SUBJECT: Forwards info re primary containment hatch boundary conditions to close out open items of NRC structural audit of 831212-16. Equipment hatch uses STRUDL code capability.

SUBJECT: Nine Mile Point Unit 2
Docket No. 50-410

NRC REQUEST NO. 11

Figure 11-1

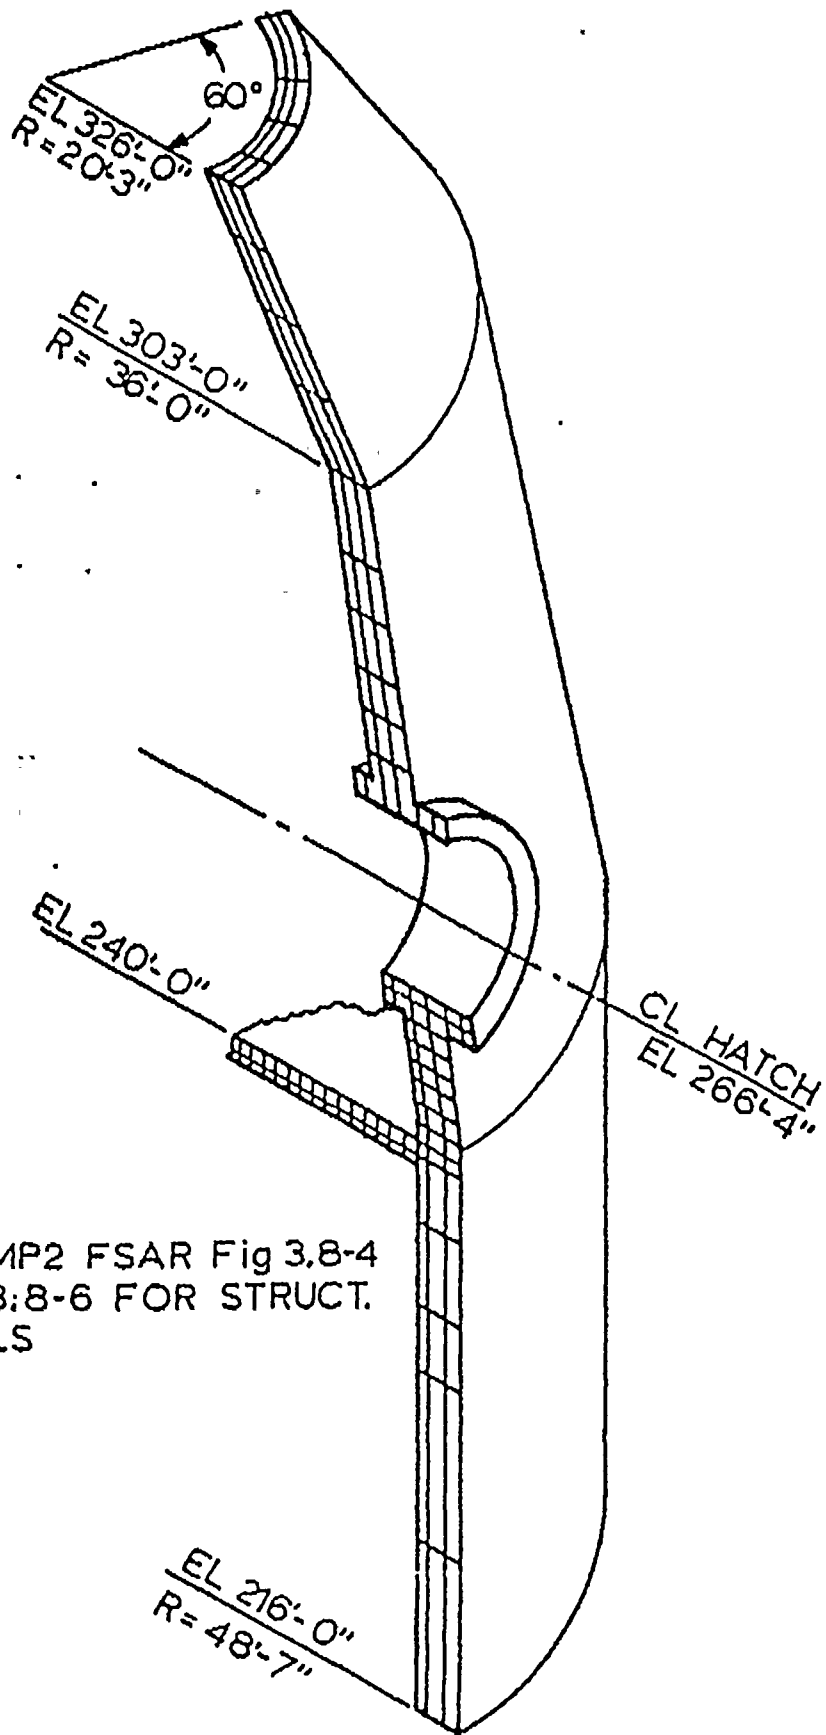
Provide a discussion on the primary containment hatch boundary conditions and the correlation of forces/displacements between the two models.

The equipment hatch of the primary containment uses the finite element capability of the STRUDL computer code and is modeled with three dimensional solid finite elements (as shown in Figure 11-1).
